DECISION AND ORDER

Property Address/Description: 34 ELLERBECK ST

TLAB Case File Number: 19 156834 S45 14 TLAB

This is an appeal from a refusal by the Toronto and East York District panel of the City of Toronto (City) Committee of Adjustment (COA) on an application to construct a parking pad in the front yard of an existing detached two-storey dwelling at 34 Ellerbeck Street (subject property).

Attachment 2.

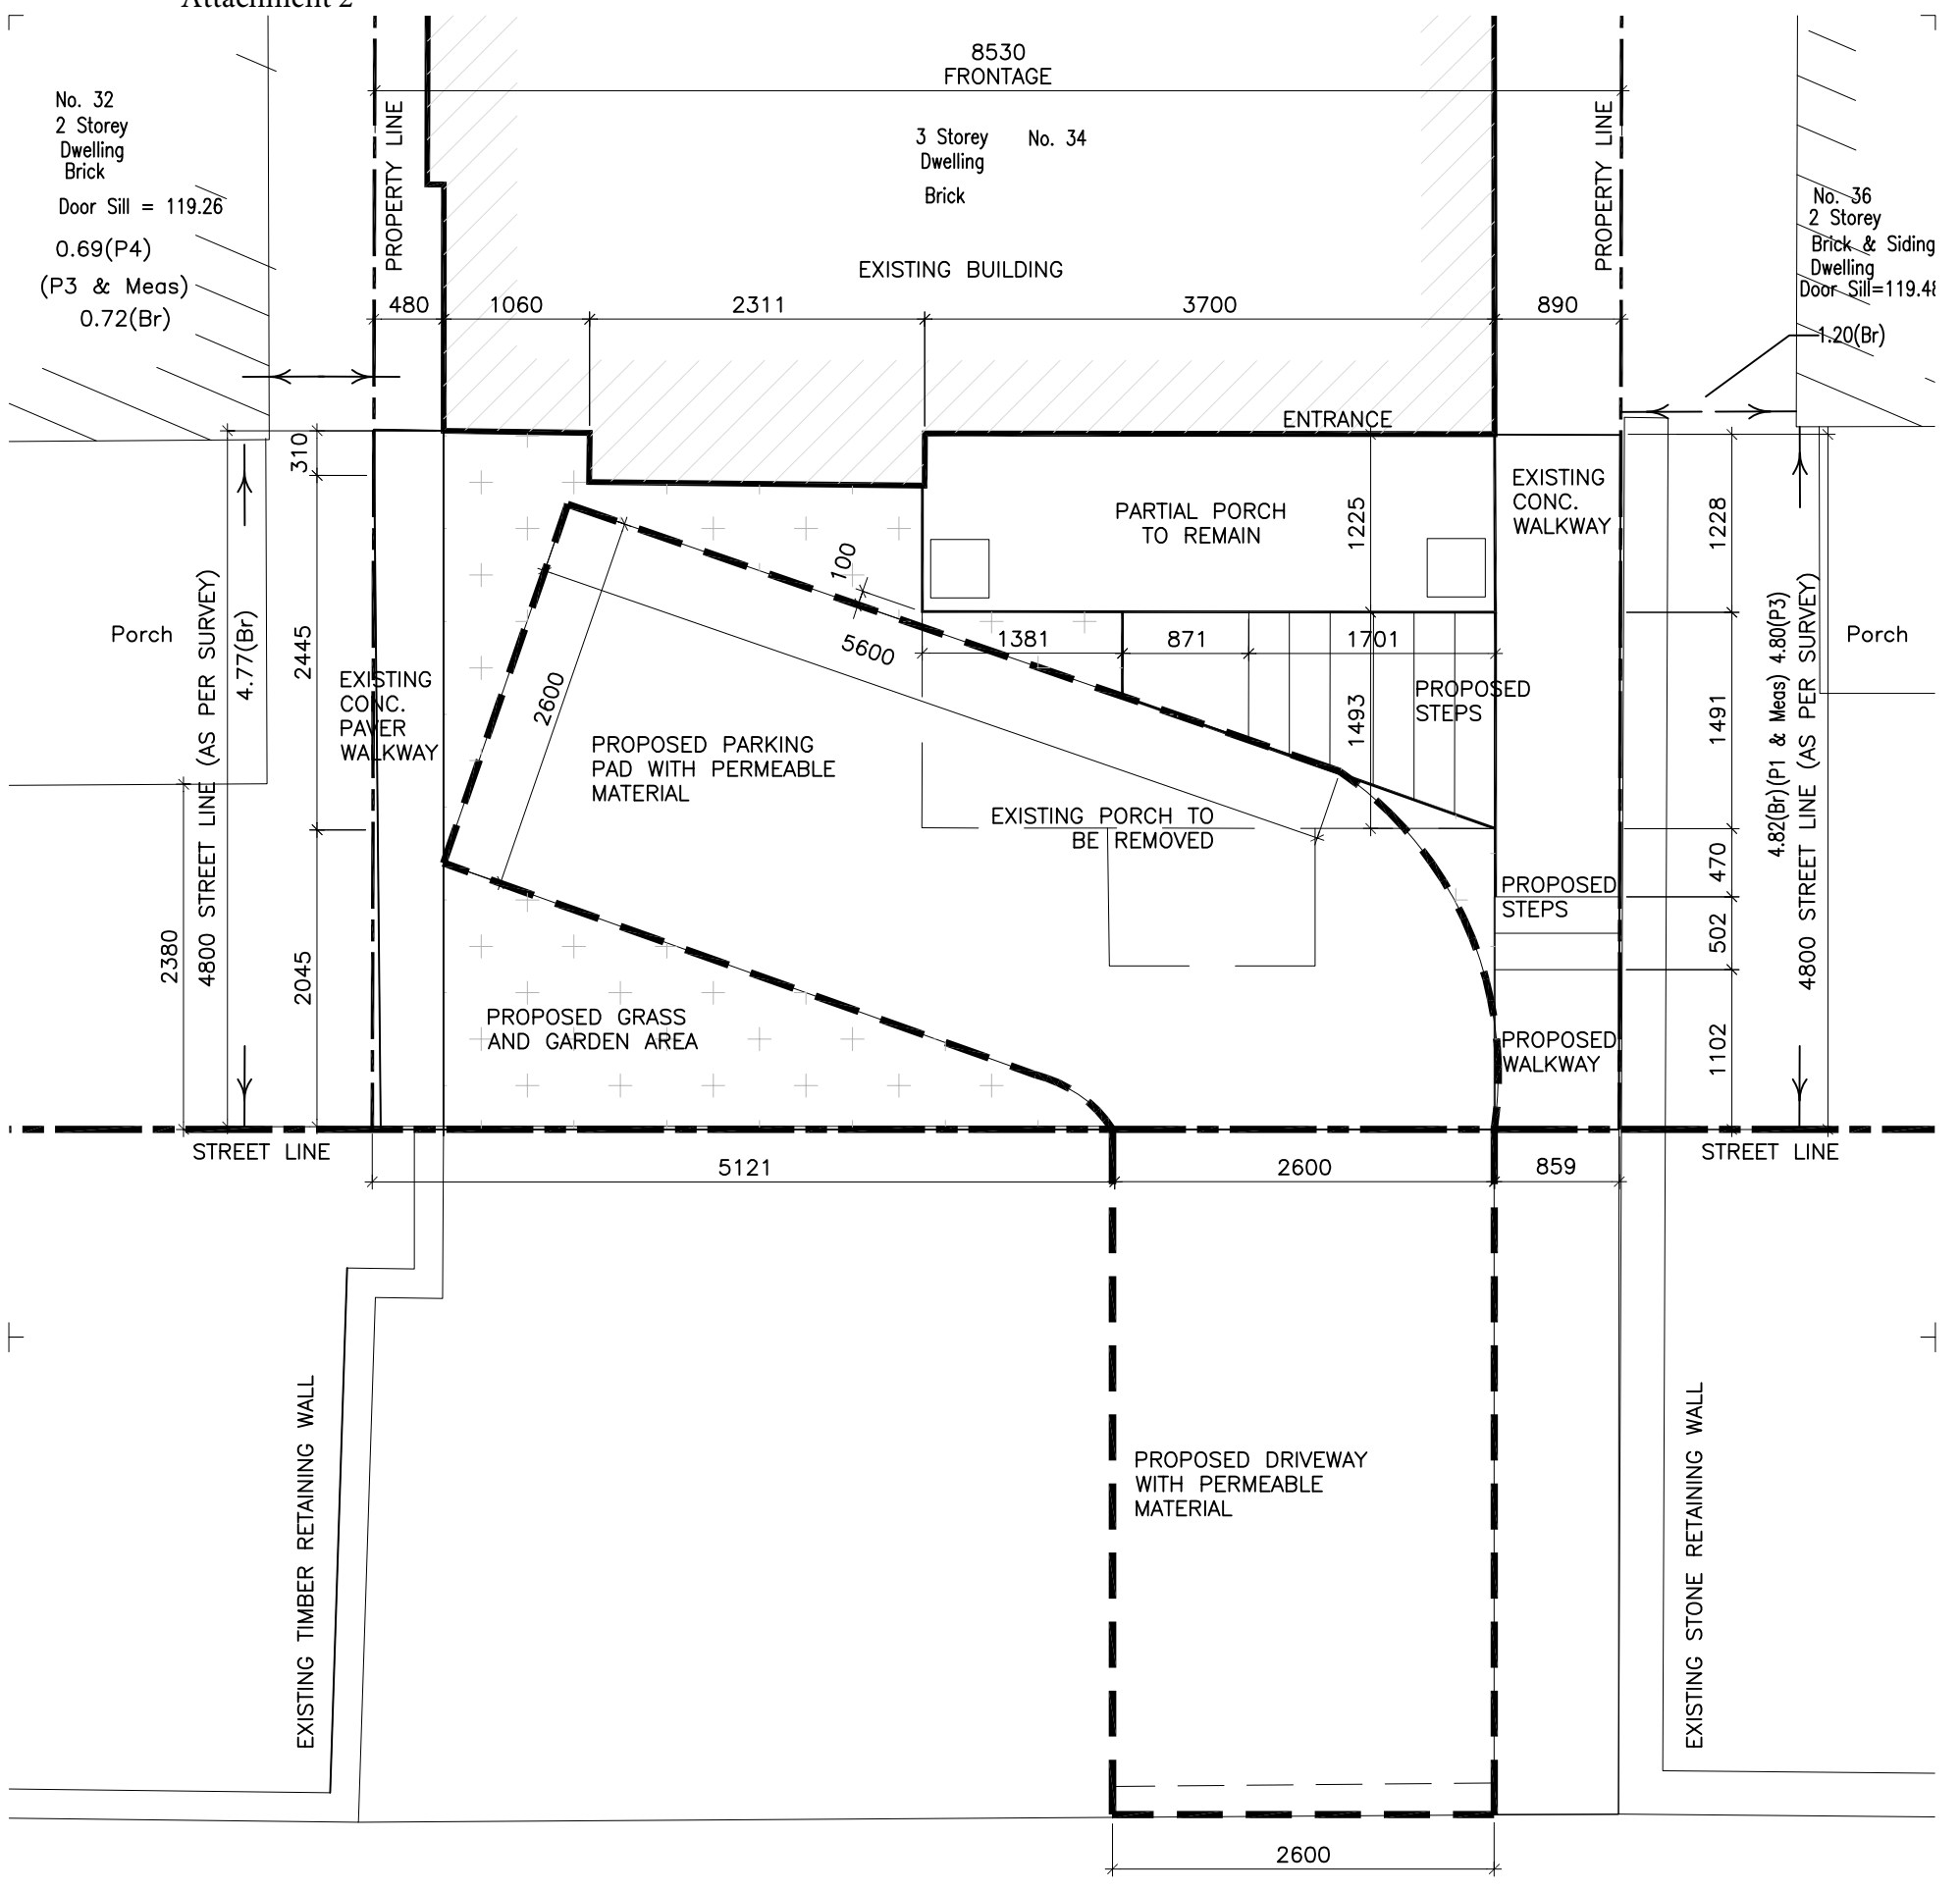
3. The site plan (**Attachment 2**) failed to demonstrate the 0.3 m separation distance required under section 220.5.1; further, that the existing porch, stairs and retaining walls are obstacles to turning movements. She felt the orientation of the space is 'out of character' and contrary to traffic flow on the street, unusual, difficult; further, the proposal contravened the very issues that the 2018 Traffic Management Report had identified and was endeavouring to alleviate, including the loss of one on-street parking space and pedestrian safety concerns.

Mr. William Habkirk had lived nearby for 41 years and strongly objected to the requested variances. His Participants Witness Statement is Exhibit 5. He cited what he felt to be several inaccuracies in the Site Plan, **Attachment 2**, including:

- i). The width of the sidewalk, it being reduced to 0.65 m (two feet) after deleting the existing retaining wall (200mm);
- ii). The location of the 'existing' stairs, as patently not where they are represented.
- iii). The necessary removal of the existing stairs and porch.

However, I find the proposal in **Attachment 2** constitutes a 'gerrymandering' of the required space in a manner that is disruptive to the continuity of the streetscape, diminishes the character of the dwelling itself, and creates an unconventional patchwork

I find that the design proposal causes partial demolition of an existing newly constructed porch and garbage storage area, creates turning movement conflicts with the built form of the dwelling and its stairs, and creates an entrance sidewalk of minimal dimensions, even if incorporated into the design with permeable pavers.

The plotting of the proposed space, even as presented in **Attachment 2**, does not appear to be entirely on private property and does not afford the 0.3 m turning dimension referenced by Ms. Hong.

I find the turning angle proposed to be awkward, conflicted and a potential risk to public health and safety. If allowed to be constructed, I am confident that users will not use the angle, or could seek to park two cars. I find that out of convenience, for safety in all seasons and by human nature, future occupants or visitors will park perpendicular to the street, encroaching on the public boulevard, albeit not necessarily the sidewalk.

5. The diagram or Plan as identified in **Attachment 2** is not approved.
